Te Kauru FMP Audit Report

Client: Greater Wellington Regional Council

Report by: Matthew Gardner & Vicki Henderson

TE KAURU FLOOD PLAIN MANAGEMENT PLAN

Figure 5-2 – Comparison of GWRC 50 year flood extent layer with latest 50 year model results (Upper Ruamāhanga River)

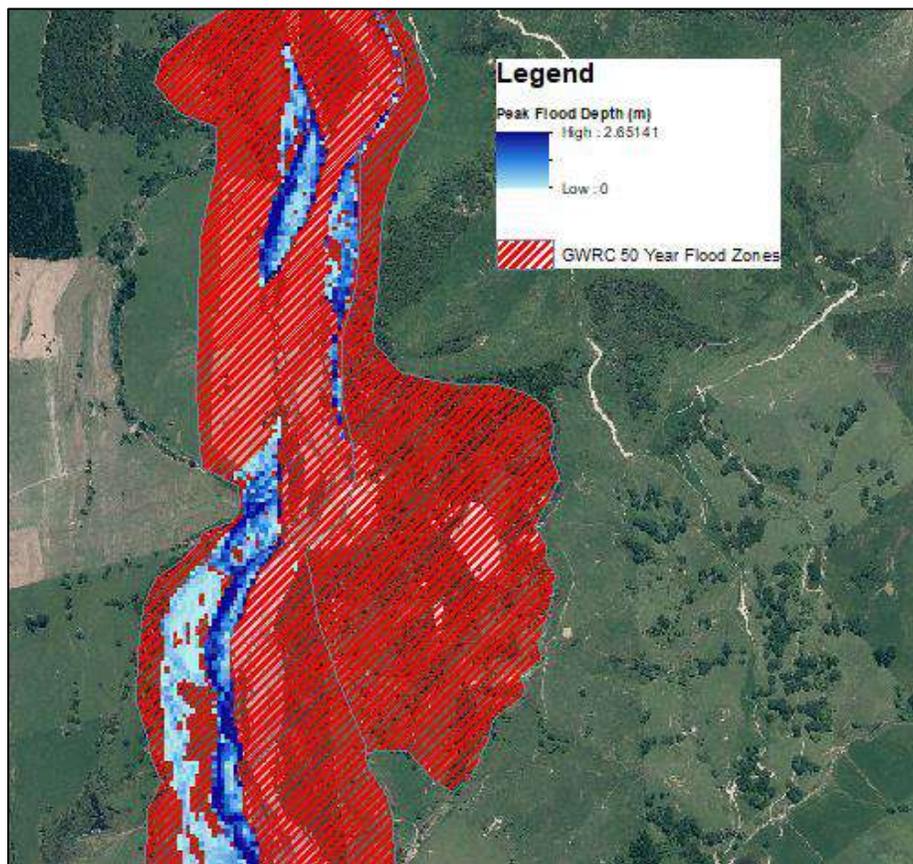
A comparison of a select area of the Ruamāhanga model results is made with the GWRC 50-year flood zone layer in Figure 5-7 below. In this location the modelled flood extent is significantly narrower than that in the 50 year flood extent on record. The reason for the reduction in flood extent may need to be investigated. This does not necessarily indicate the modelling is wrong in this location as the reason for the differences may be easily be able to be explained (ie due to more detailed data currently available, or changes in the catchment).

Figure 5-3 – Water level profile at KopuBridges 4221 and 4167

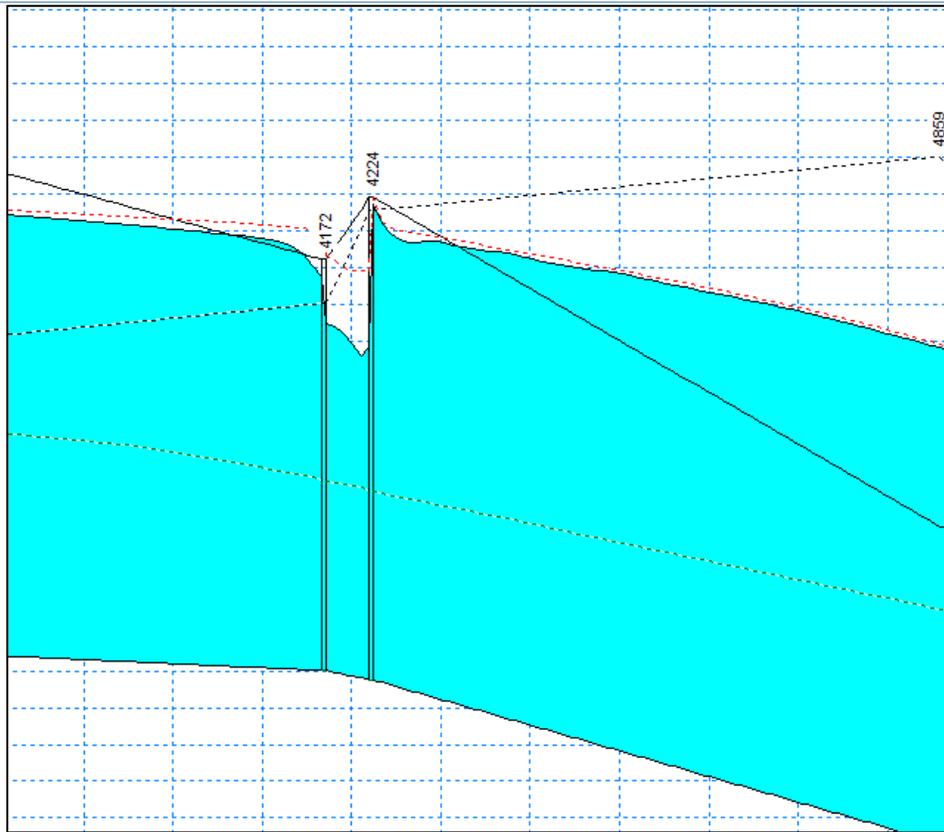
The MIKE11 results have also been checked at each structure to check for any obvious instabilities. The MIKE11 results have highlighted some issues at the culverts labelled 'KopuBridges4221 and KopuBridges 4167'. Water level results present some instabilities as shown in Figure 5-3. A closer inspection of the bridge setup indicates the following;

- The two culverts have cross sections spaced only 1m upstream of the structure – this would require a very small dt in order to compute;
- There is also no slope across the culvert. A small slope on the culvert will likely assist with stability.

The culvert setups at KopuBridges 4221 and 4167 and the bridge setup at KopuBridge 15583 are reconsidered in order to remove the instabilities present in the 100 year CC results.

Figure 5-5 – Water level profile at KopuBridge 15583

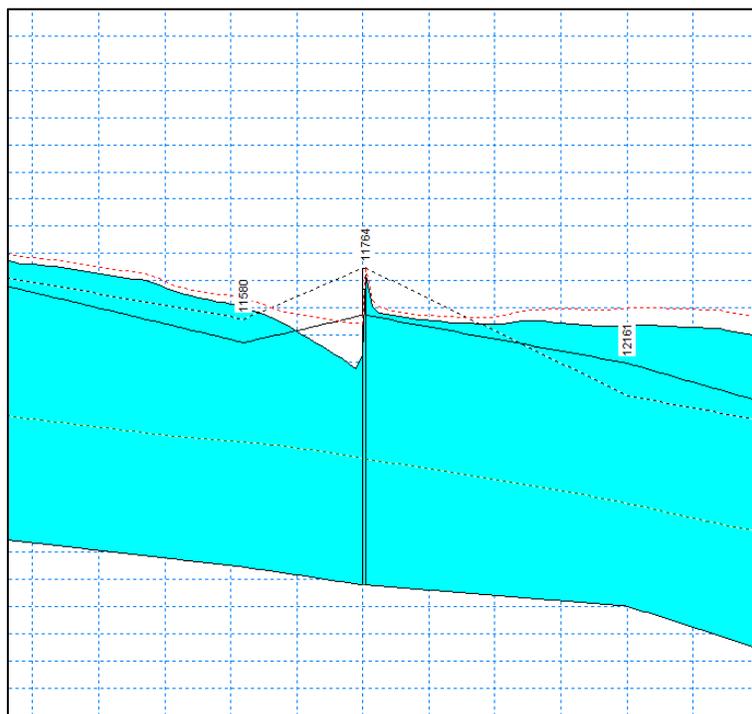
- the upstream cross section is spaced only 1m upstream. The MIKE11 manual recommends that the upstream cross section is placed at least as far upstream as the opening width (see Figure 5-4 below)
- The bridge setup also has no length or slope applied. Applying a small slope may assist with stability.

Figure 5-7 – Comparison of GWRC 50 year flood extent layer with latest 50 year model results (Kopuaranga River)

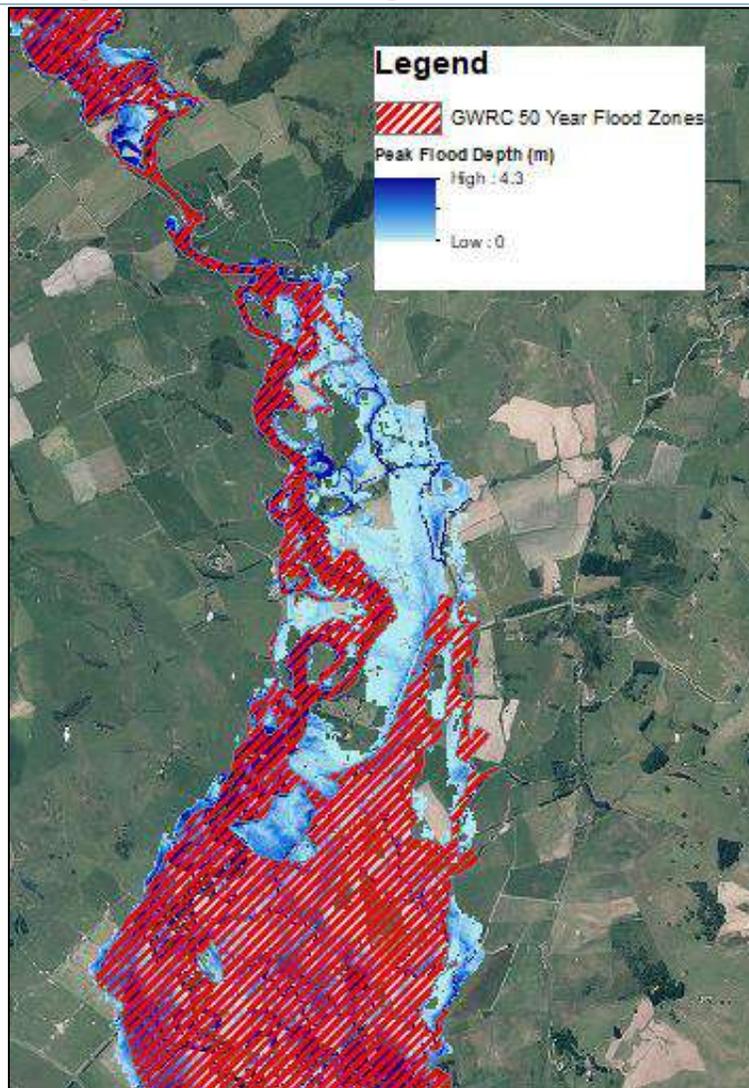
A comparison of a select area of the Kopuaranga model results is made with the GWRC 50 year flood zone layer in Figure 5-7 below.

It is considered that some degree of documented model validation/verification would be prudent.

Figure 5-9 - Comparison of GWRC 50 year flood extent layer with latest 50 year model results (Whangaehu River)

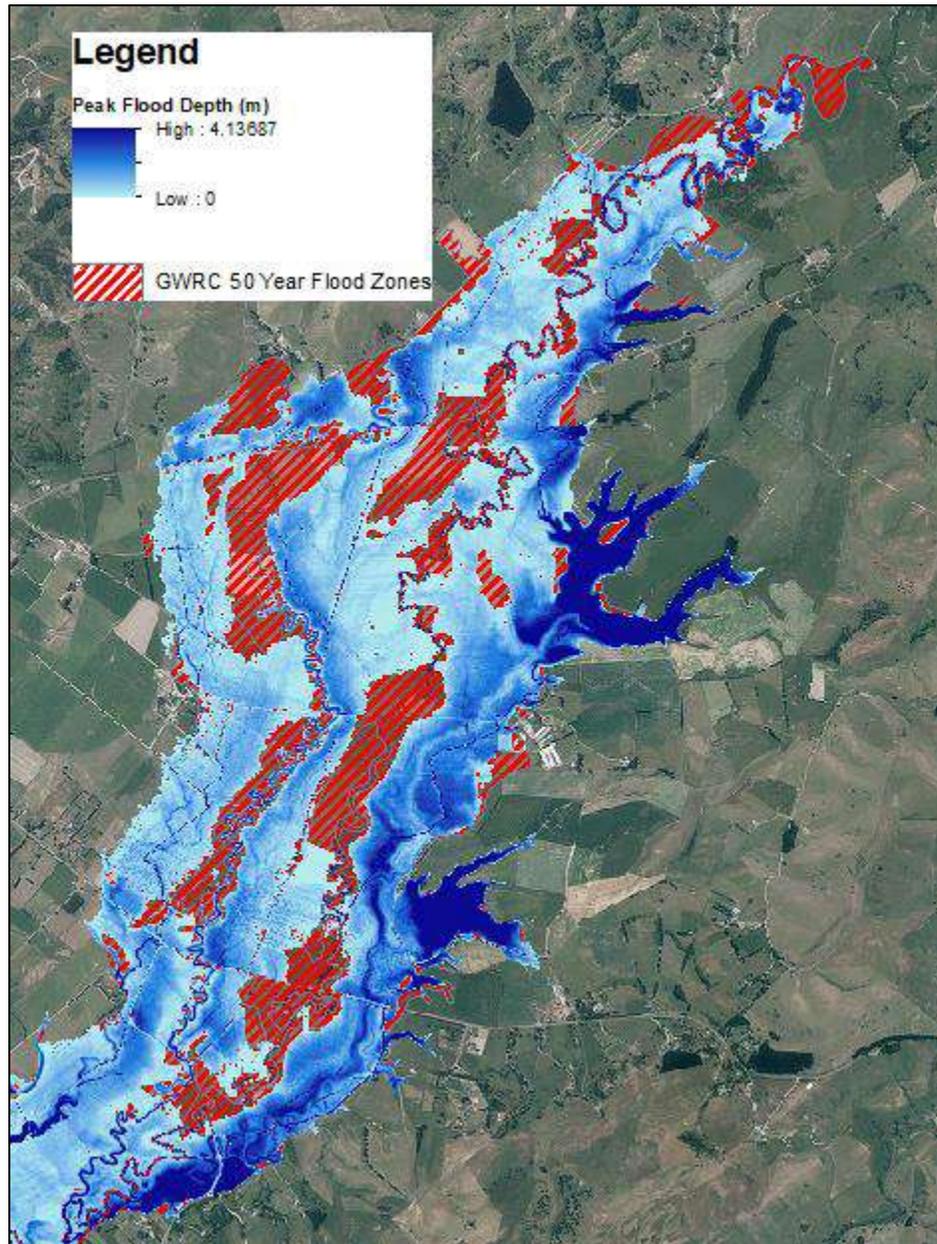
A comparison of a select area of the Kopuaranga model results is made with the GWRC 50 year flood zone layer in Figure 5-9 below. In general the modelled flood extent for the Whangaehu River seems to match fairly well with the historic extents.

It is considered that some degree of documented model validation/verification would be prudent.

Figure 5-10 – Visualisation of shift due to possible incorrect geographic transformation

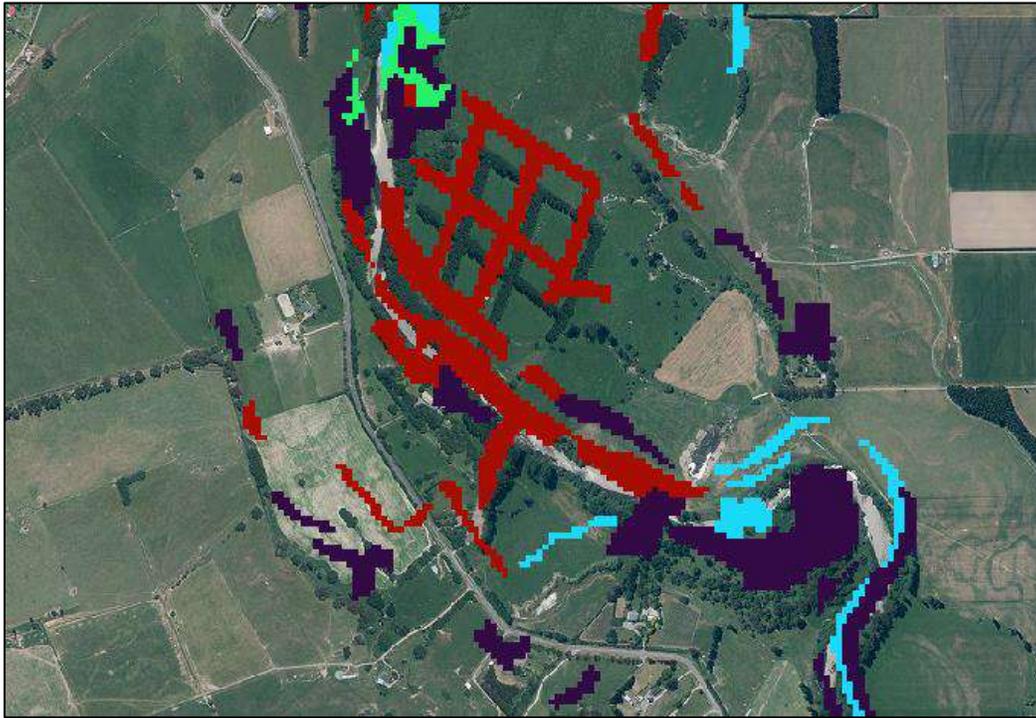
not appear to align with the underlying terrain model or imagery and are shifted north by approximately 70m.

Figure 6-2 - Comparison of GWRC 50 year flood extent layer with latest 50 year model results (Waingawa River)

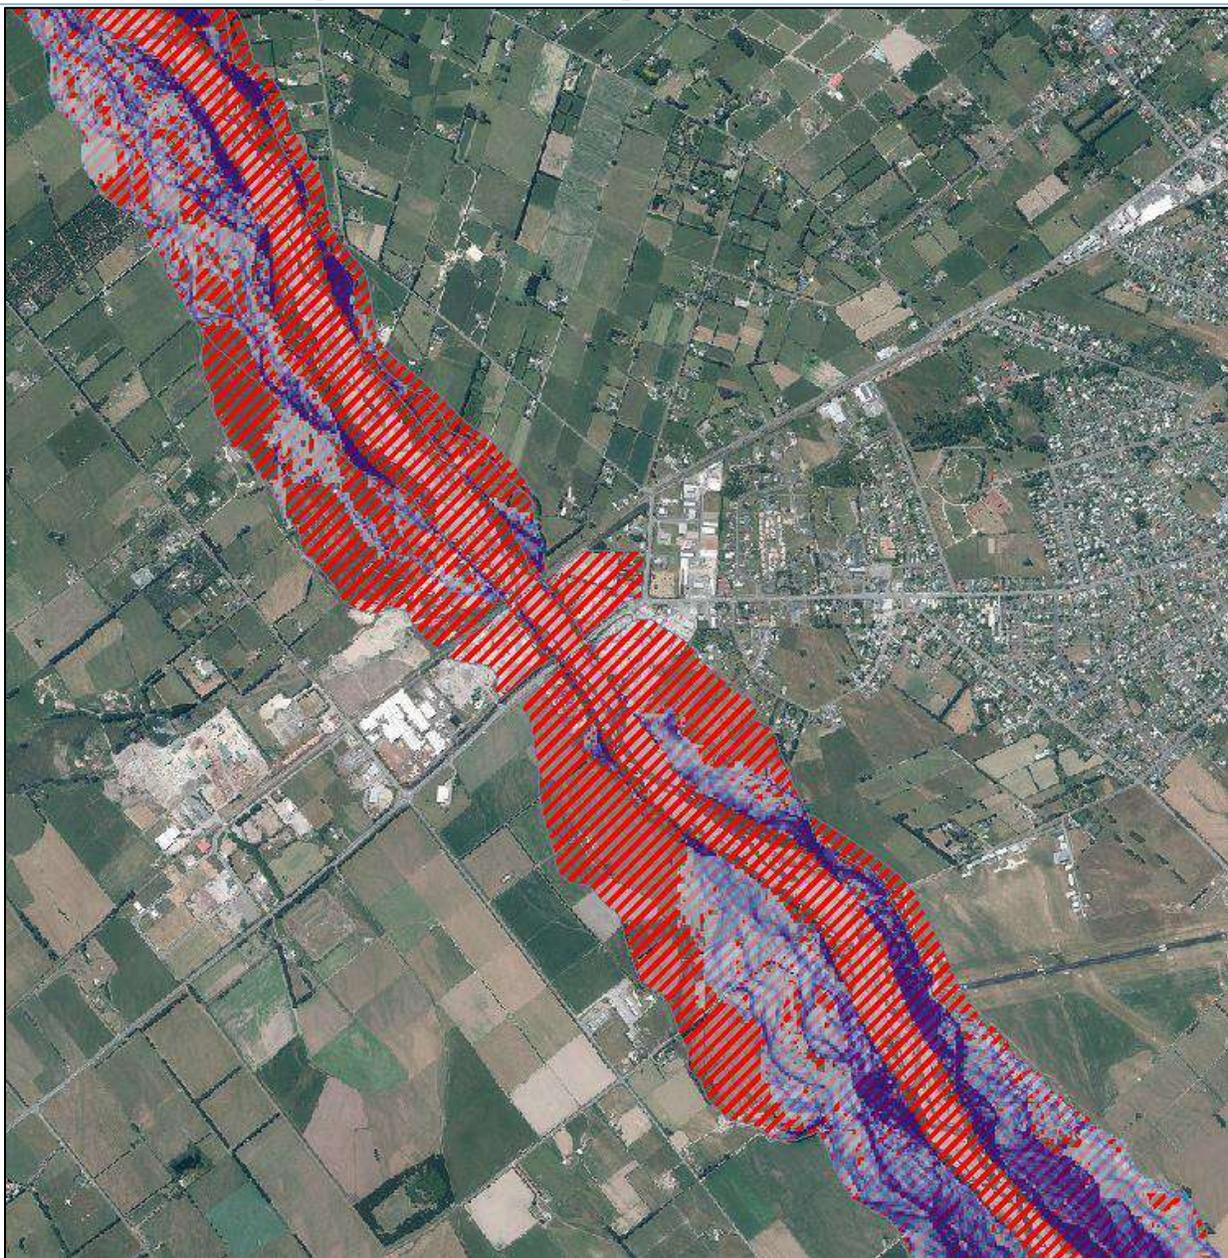
Comparison for a select area of the Waingawa model results is made with the GWRC 50 year flood zone layer in Figure 6-2 below. In general the modelled flood extent for the Waingawa River seems to match fairly well with the historic extents however in some areas such as in the vicinity of the bridges, the new flood extent is significantly less than the historic 50-year flood layer. This may indeed be sensible, however some commentary around the differences would be warranted.

Figure 6-3 – Visualisation of MIKE11 model results in location of instability

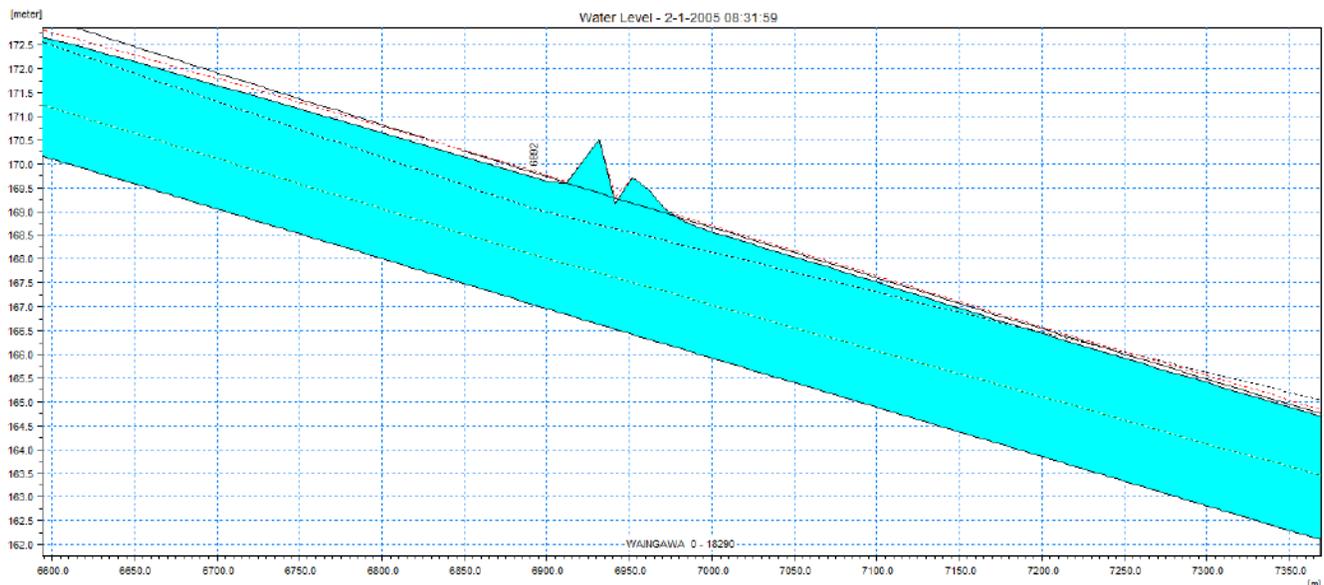
One minor instability has been noted in the MIKE11 results at chainage 6829, this does not appear to propagate into the 2D results, however may want to be tidied up if further work is done in the model in the future.

Figure 6-5 - Comparison of GWRC 50 year flood extent layer with latest 50 year model results (Taueru River)

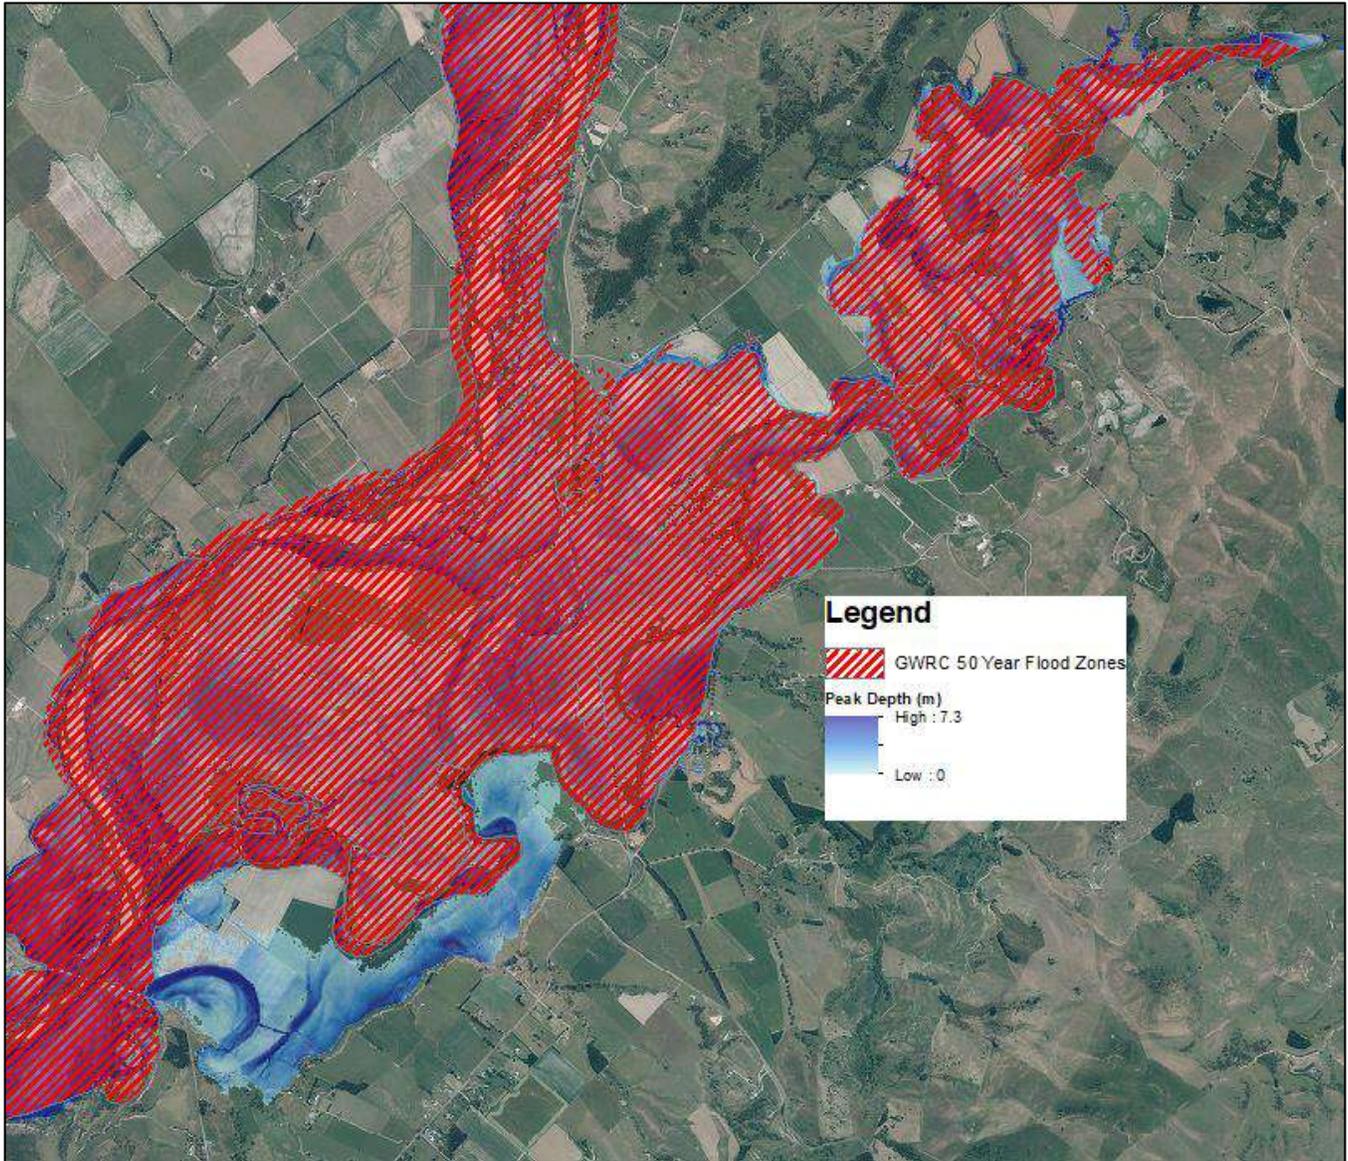
on the true left bank in the lower reaches. These differences would warrant some further investigation to ensure the results are sensible.

Figure 6-9 - Comparison of GWRC 50 year flood extent layer with latest 50 year model results (Ruamāhanga River)

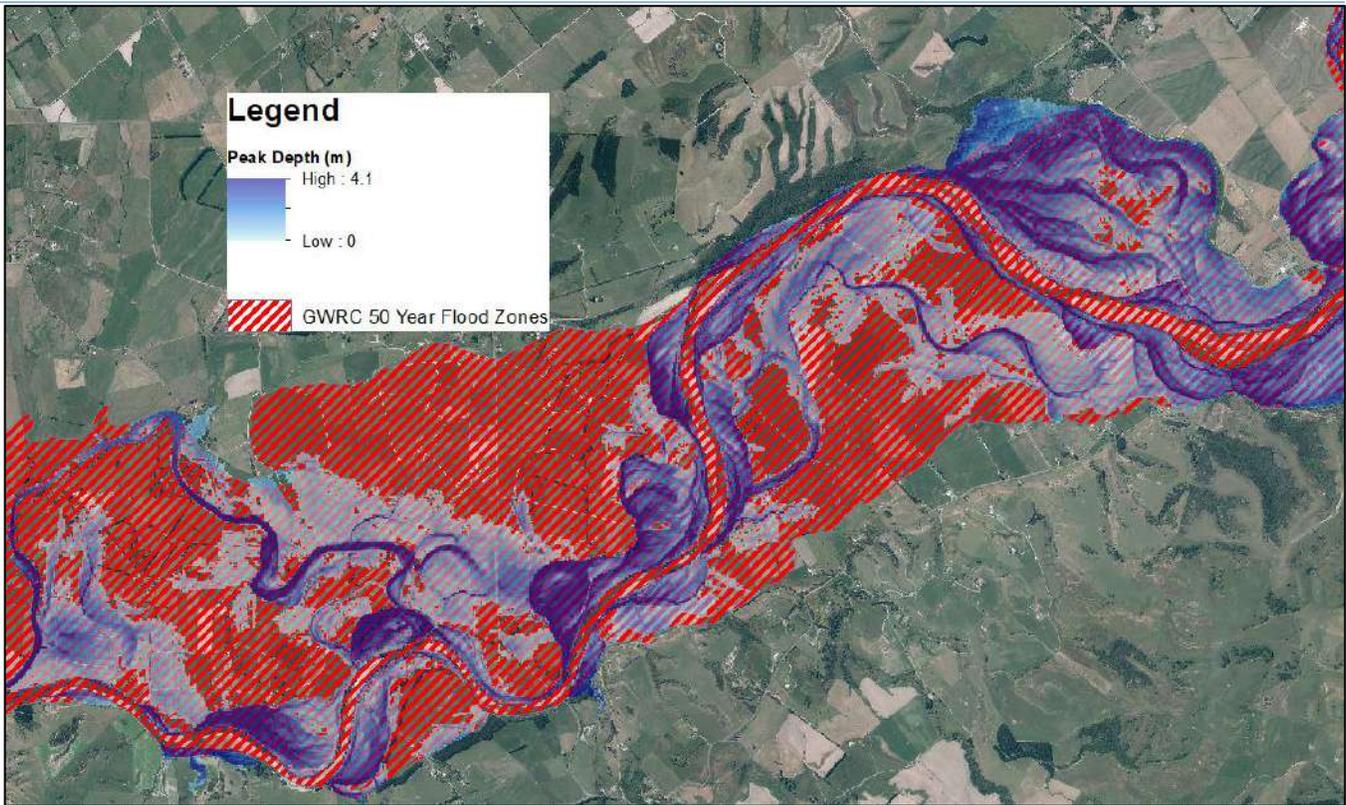
A comparison of a select area of the Ruamāhanga model results is made with the GWRC 50 year flood zone layer in Figure 6-9 below. In this location the modelled flood extent is significantly narrower than that in the 50 year flood extent on record. The reason for the reduction in flood extent may need to be investigated. There is a possibility that changing the lateral link elevation source to M21 from HGH as recommended in section 6.2 will allow more water to spill from the river certain locations.
